Proposal for amendments to Regulation No. 13 (Heavy vehicle braking)

Submitted by the expert from Denmark, coordinated and supported by the International Road Transport Union, International Commission of Technical Affairs (IRU CIT) and the Nordic Road Association, Vehicles and Transport Committee (NVF).

Diagram 1

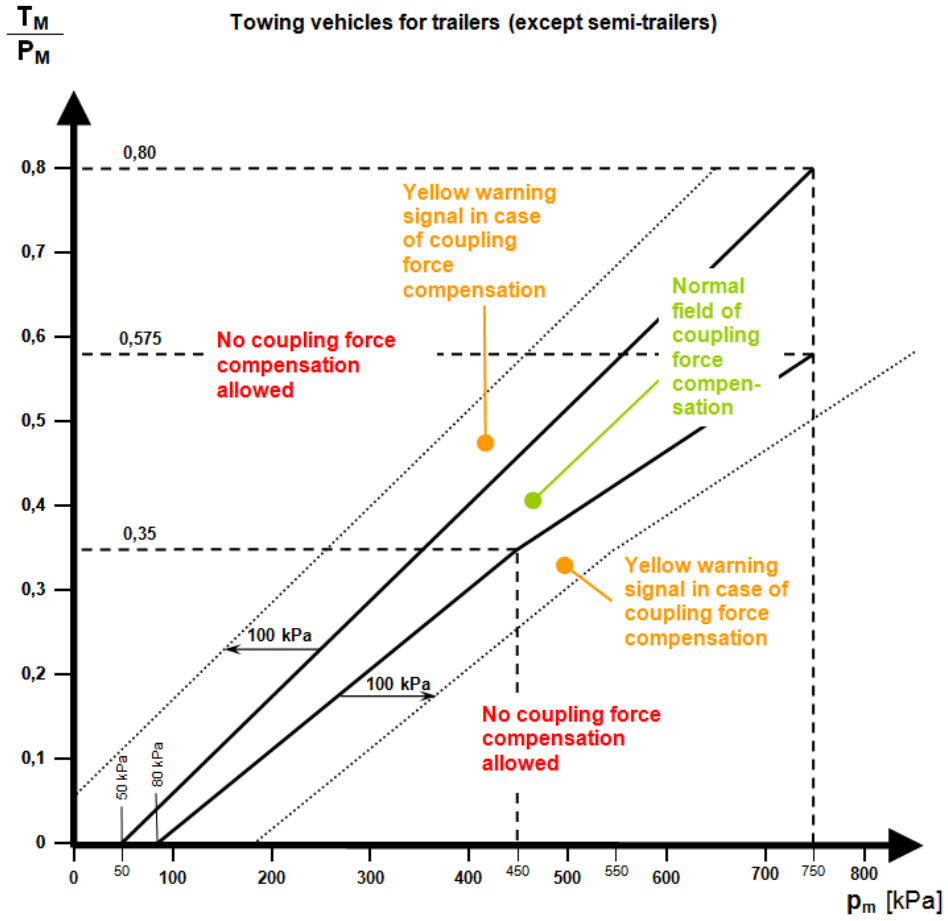
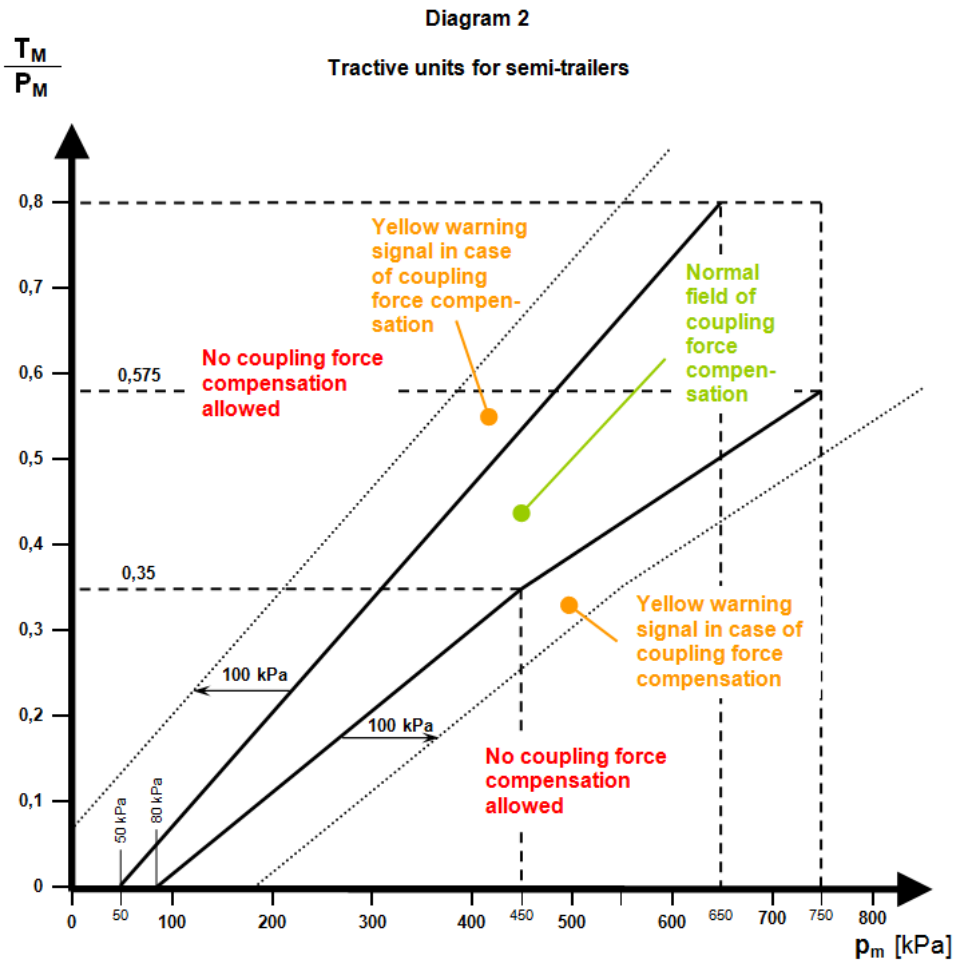
Paragraph 5.2.1.28.5., amend to read:

5.2.1.28.5. The coupling force control system shall tend to minimise the coupling force. Max. allowed compensation by the coupling force control system is 100 kPa below the lower limit of the compatibility band and 100 kPa above the upper limit of the compatibility band as specified in Annex 10. If this compensation causes the operating point to lie outside the compatibility band as specified in Annex 10 for the motor vehicle the yellow warning signal specified in paragraph 5.2.1.29.2 shall be activated. After recoupling no compensation is allowed before the coupling force control system has registered a difference between the braking rates of the vehicles in the combination.

DIAGRAM 2

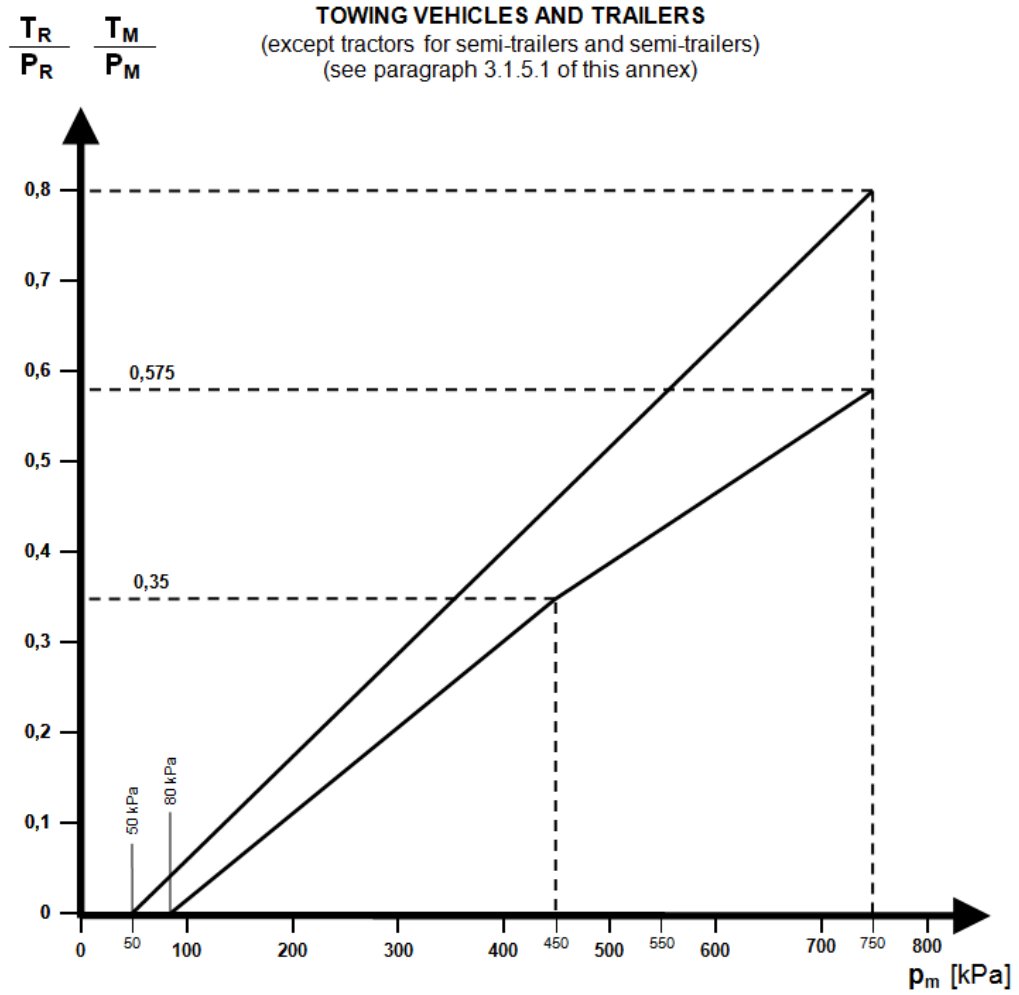
Annex 10, diagrams 2, 3 and 4A, amend to read:

DIAGRAM 4

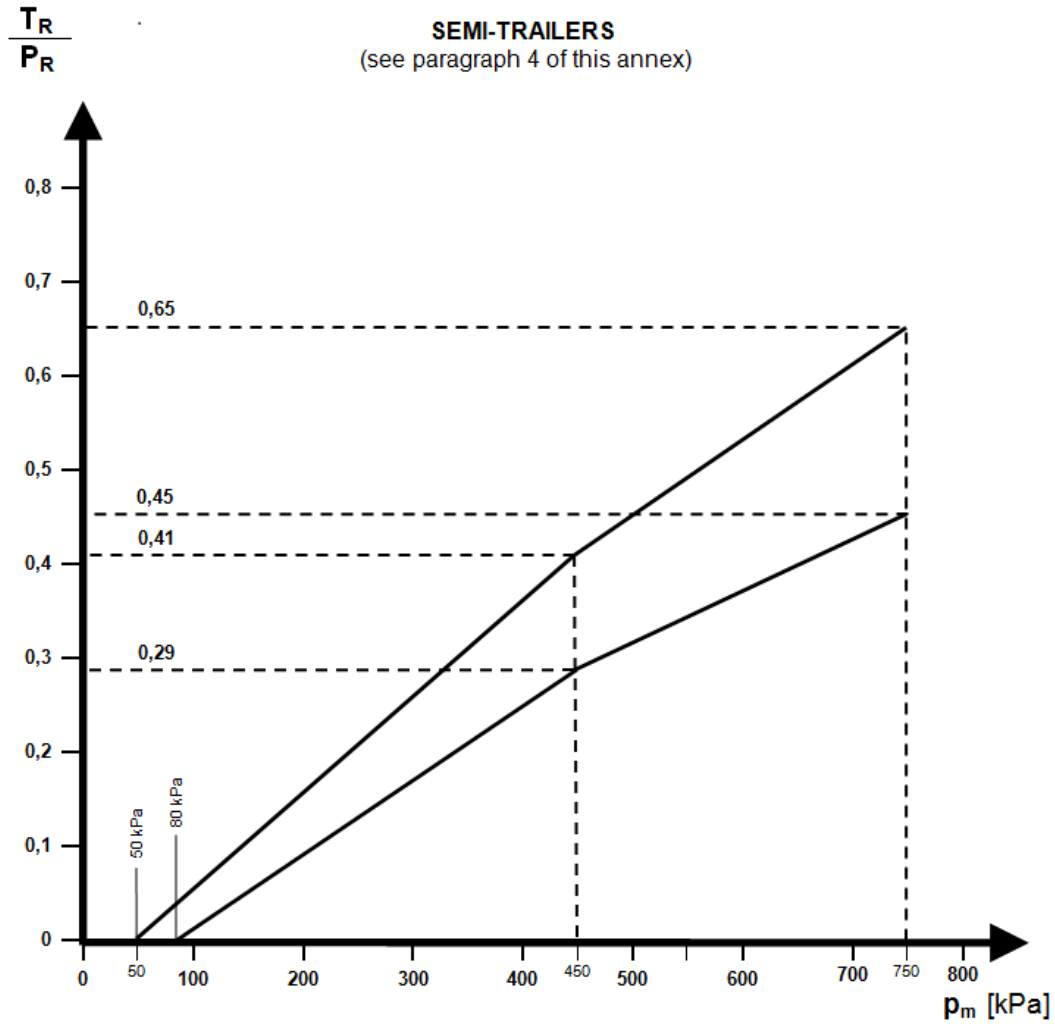
Note: The relation between the braking rate T_R/P_R and the control line pressure is determined as follows:

To determine the **hatched** area the values of the ordinates of the upper and lower limits in diagram 4 are multiplied by the factor **K**. The factor **K** is obtained by **the calculation formula described in the following.**

$$K = 1.35 - \frac{0.96}{E_R} \left(1.0 + (h_R - 1.2) \frac{g \times P}{P_{R\max}} \right)$$

DIAGRAM 2

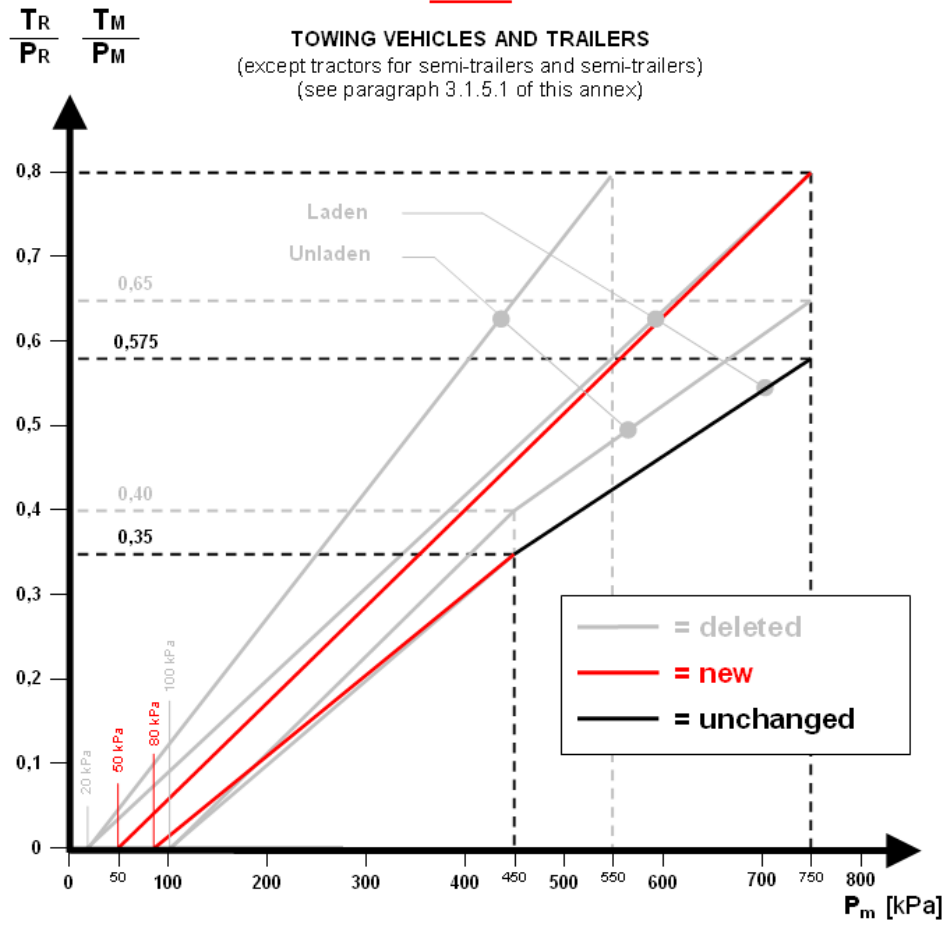
The following diagrams show the difference between the existing diagrams and the new proposed diagrams:

Annex 10, diagram 2, 3 and 4A (compatibility):

DIAGRAM 4B

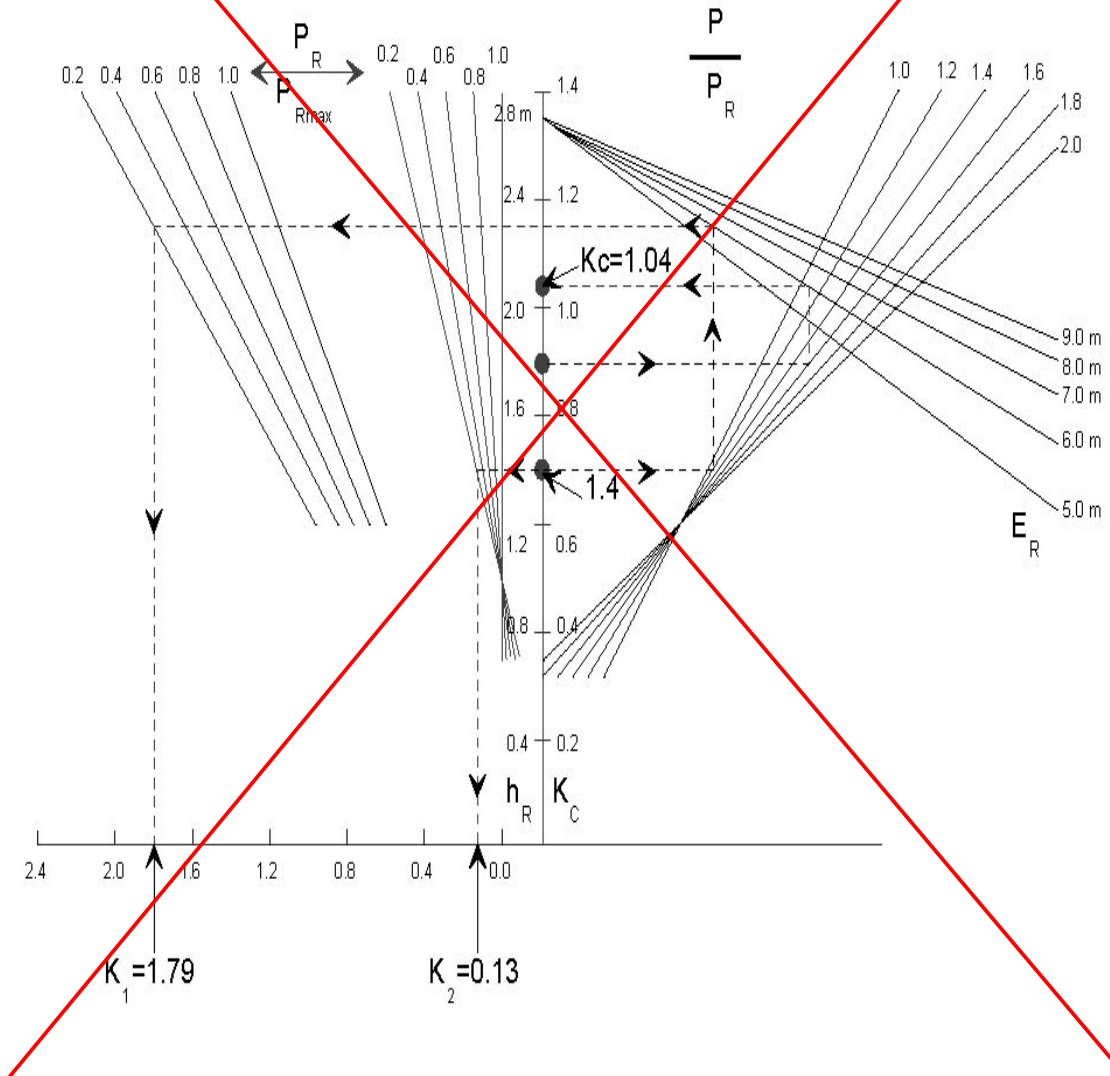
Note: The relation between the braking rate T_R/P_R and the control line pressure ~~for the laden and unladen conditions~~ is determined as follows:

To determine the ~~hatched areas corresponding to the laden and unladen conditions~~, the values of the ordinates of the upper and lower limits ~~of the hatched area~~ in diagram 4A are multiplied by the factors ~~K_e and K_v respectively~~. The factors ~~K_e (laden), K_v (unladen)~~ are obtained by the calculation formula described in the following. ~~reference to diagram 4B.~~

$$K = 1.35 - \frac{0.96}{E_R} \left(1.0 + (h_R - 1.2) \frac{g \times P}{P_{Rmax}} \right)$$
